Addendum #1

ePLANS Permit - BLD2020-01363

421 Watson St

On May 22nd, the Historic Preservation Staff requested additional information regarding the Permit Application (BLD2020-01363) and the HDC Project Review Request.

Roof damage, as viewed from inside the building

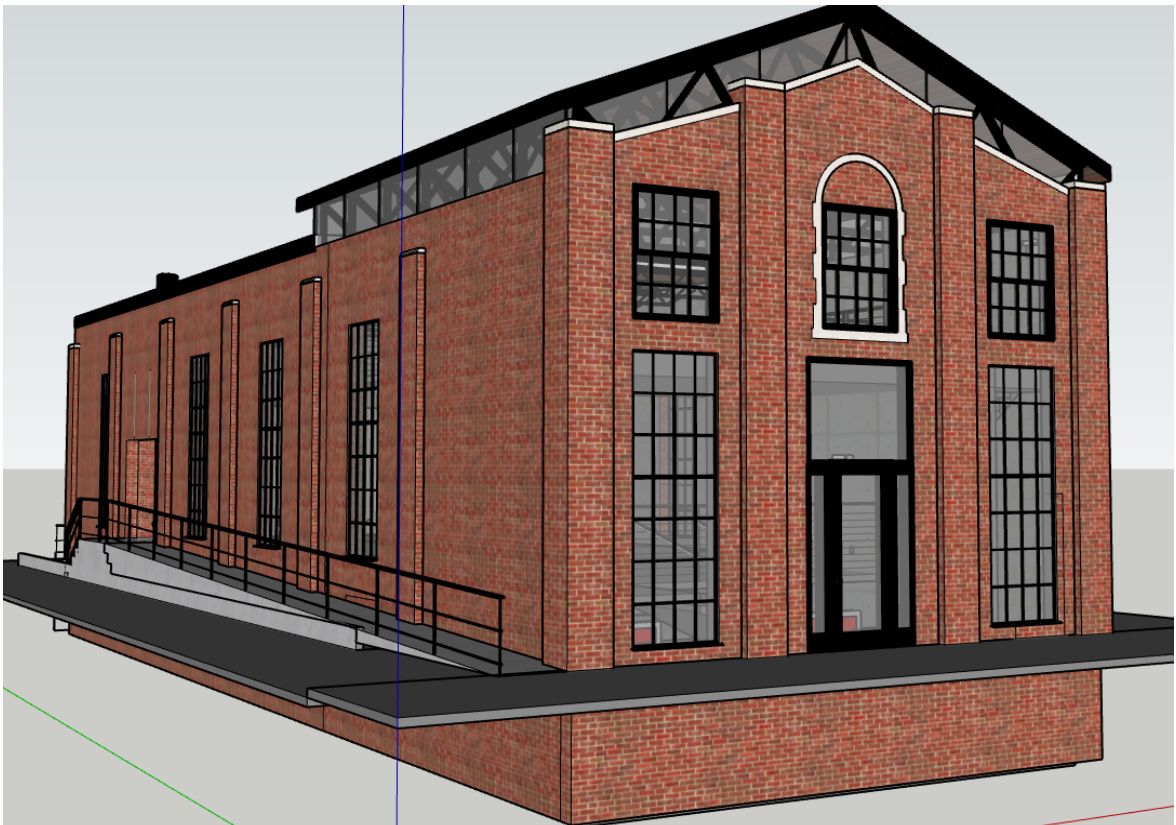
Pictures of the existing roof are unavailable as it is unsafe to access. Through years of zero maintenance, the roof has deteriorated allowing weather to also cause structural damage to the wood deck. The following picture was taken from inside the building which depicts roof damage.

The existing roof will be removed with metal trusses, insulated structural panels, and a metal roof added to enhance the appearance and focus the visibility of the masonry roof line. The structural panels will be clear glass allowing for ambient lighting inside the building. A brochure of the metal roofing system from Firestone was included in the previous submittal. For an example of the insulated glass panels, please see Attachment 1 from Guardian Glass.

SOUTH ELEVATION

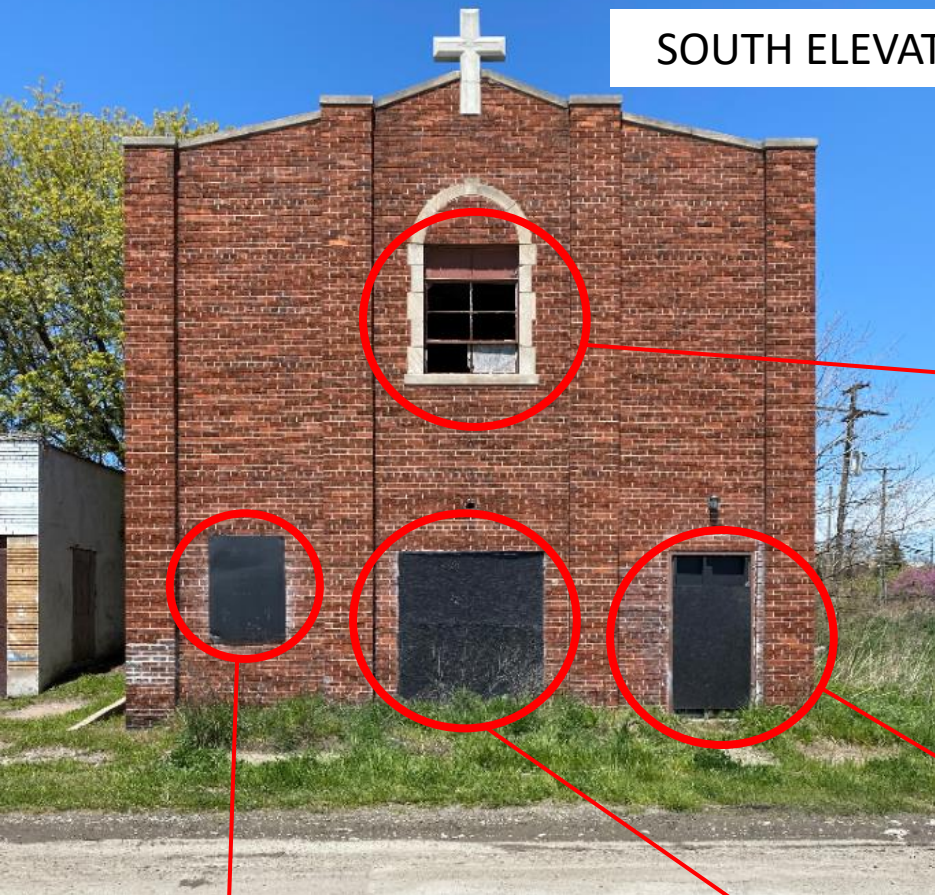
This is a sign mounted to the brick (not a window).

EAST ELEVATION

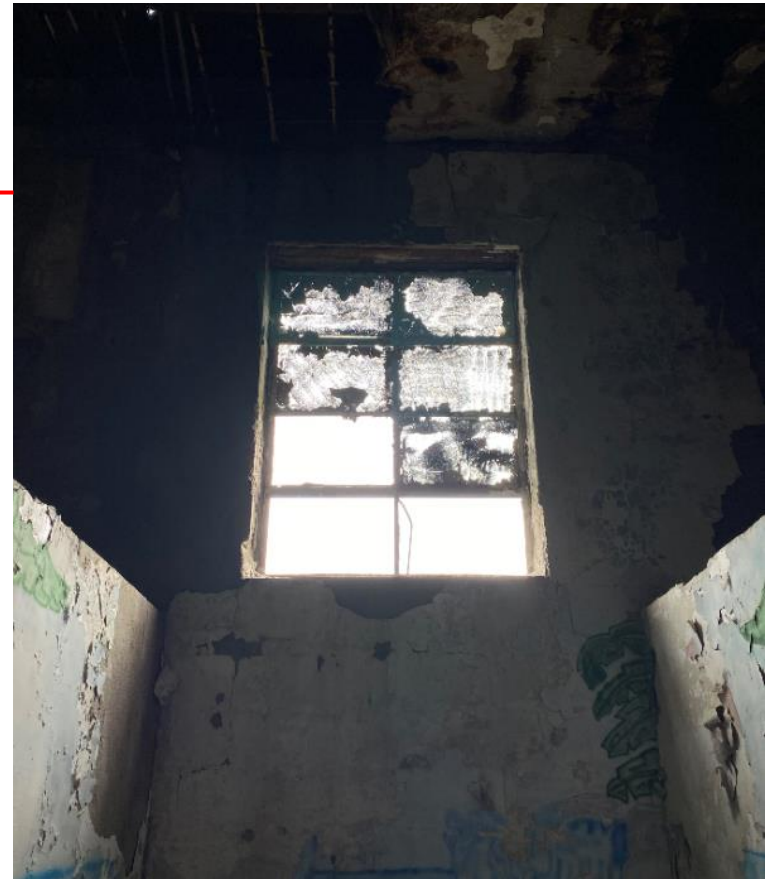
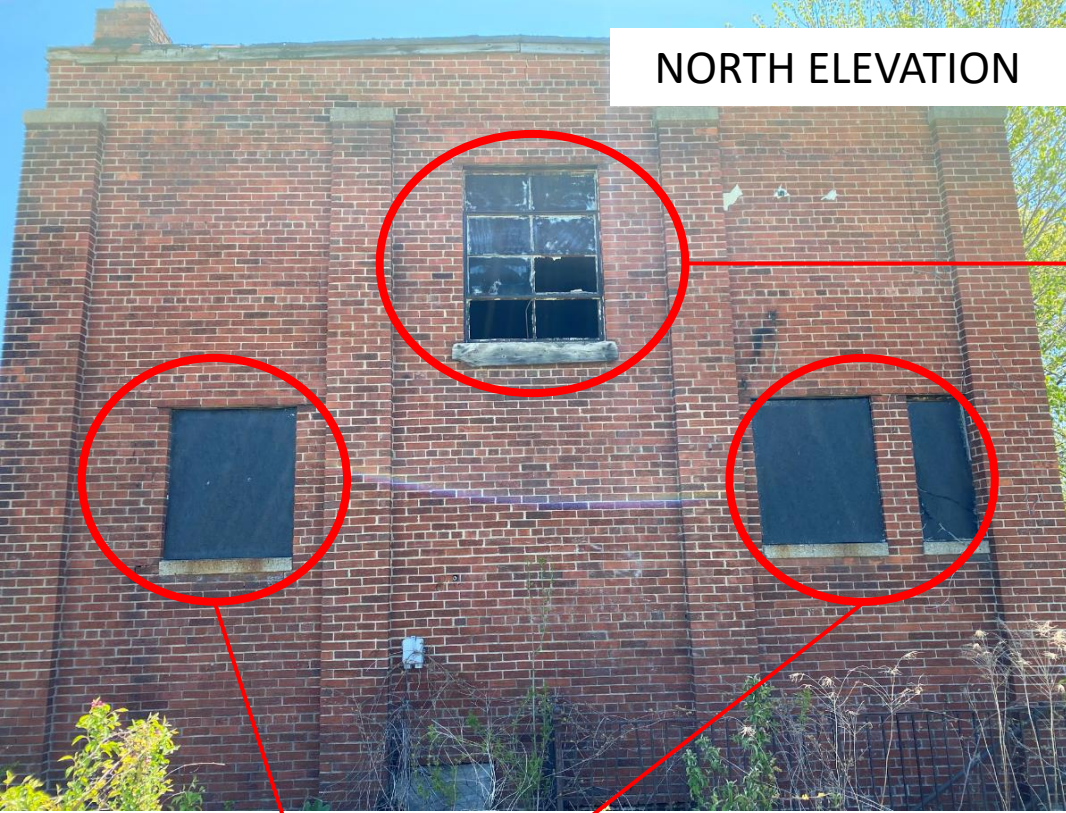
Please see Attachment 2 for pictures of each window and door from both the exterior and interior. All the windows have been boarded over as the glass panes have broken and removed. Unfortunately, the years of deterioration have made all parts of the windows and doors unsalvageable. Ron Hendricks, a carpenter with over 30 years of residential and commercial experience, was consulted and expressed the following opinion

“We don’t see any way possible to restore the existing windows. Quality’s suggestion would be to use Quaker H600 as a historic replication with the proper site lines and SDL (Simulated Divided Lights) bars “.

WEST ELEVATION

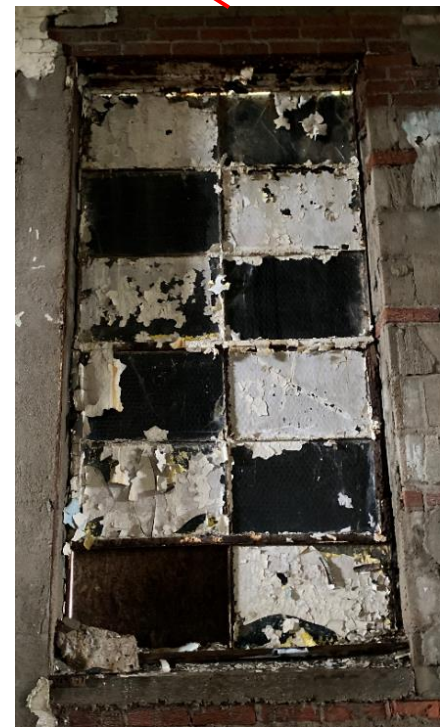
Obstructed by adjacent building
